# WILLISTON, VERMONT

### HP 24-04

## Historic and Design Advisory Committee (HDAC) Staff Report

<b>Application Stage:</b> Certificate of Appropriateness	<b>Submitted:</b> June 18, 2024
<b>Application No:</b> HP 24-04	<b>Project Name:</b> Roof Replacement
<b>Property Address:</b> 7997 Williston Road	<b>Property Owner:</b> Blair Knowles & Matt Parisi
<b>Tax Parcel #:</b> 14-104-150-000	<b>Existing Lot Size:</b> 0.5 acres

Figure 1. Blue = existing slate. Orange = existing shingles.

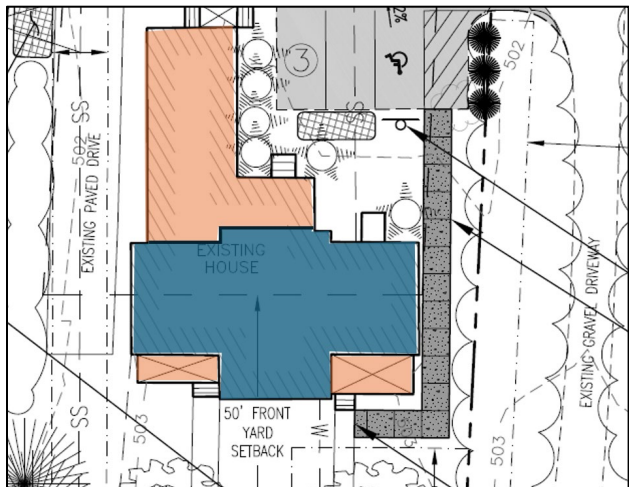
**Project Description:** The applicant proposes to replace the existing slate roof on the main block with asphalt shingles. The two front porches and rear addition are currently shingles and can be replaced in-kind at any time without HP/COA review.

**Staff Recommendation to HDAC:** First, the HDAC should decide if enough information is provided. At the time of agenda posting on 6/26, the applicant had not submitted information about the proposed material brand/specifications or photos of the existing roof. This information may be available before or at the 7/2 meeting. If more information (or more time to review) is needed, the HDAC may continue to July 16<sup>th</sup>. Second, the HDAC should consider the guidance of Appendix H and issue a recommendation for the DRB to consider. **July 2<sup>nd</sup> update:** See pages 8-18, which were provided this morning. The applicant has provided options for metal roofing and an article with several asphalt shingles options that look like slate.

- Material consistency between main block roof and porch/addition roofs is preferred if a non-slate material is required for main block.
- Materials preferred: Asphalt shingles, artificial or real slate
